Service Bulletin

Bulletin No. 2017-64 OEM No. 2017-63
Circulate to:	Sales Manager	Accounting	Service Manager	Technician	Parts Manager

Design 2 Joystick Inspection and Software Reflash for Mercury Sterndrive Diesel

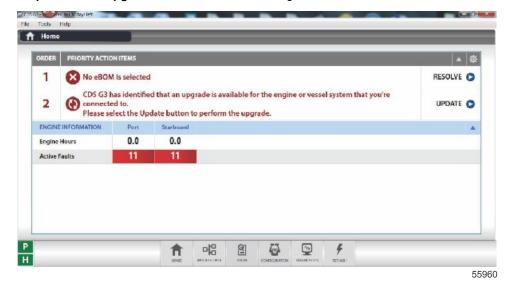
If the joystick is equipped with the external noise suppressor, replace the joystick/noise suppressor assembly. The following two images show the differences between the two designs.

IMPORTANT: Do not remove the external noise suppressor assembly from the joystick. If additional length is needed to accommodate the shorter lead on the replacement joystick, order extension harness 879171T01.
